MIL-F-15733/49G
AMENDMENT 2
10 August 1990
SUPERSEDING
AMENDMENT 1
31 May 1989

MILITARY SPECIFICATION SHEET

FILTERS AND CAPACITORS, RADIO FREQUENCY INTERFERENCE, HERMETICALLY SEALED, STYLE FL93

This amendment forms a part of MIL-F-15733/49G, dated 2 November 1988, and is approved for use by all Departments and Agencies of the Department of Defense.

FIGURE 1. Case dimensions and circuit diagrams - Continued.

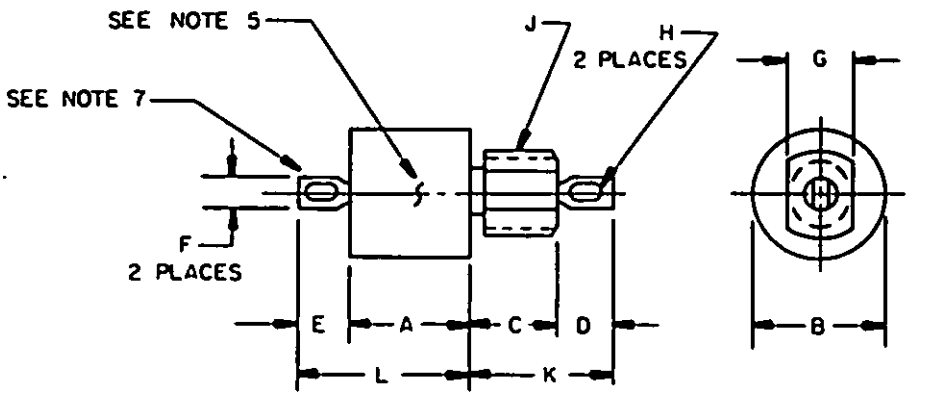
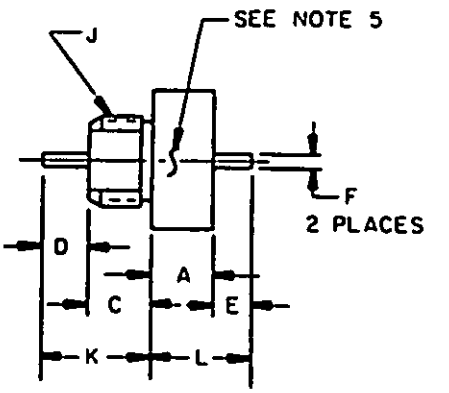
* FIGURE 1, delete the figures for dash number "0007" and dash numbers "0002 through 0006, 0008, and 0010" and substitute:

DASH NUMBERS 0002 THROUGH 0006,0008,AND 0010

DASH NUMBER 0007
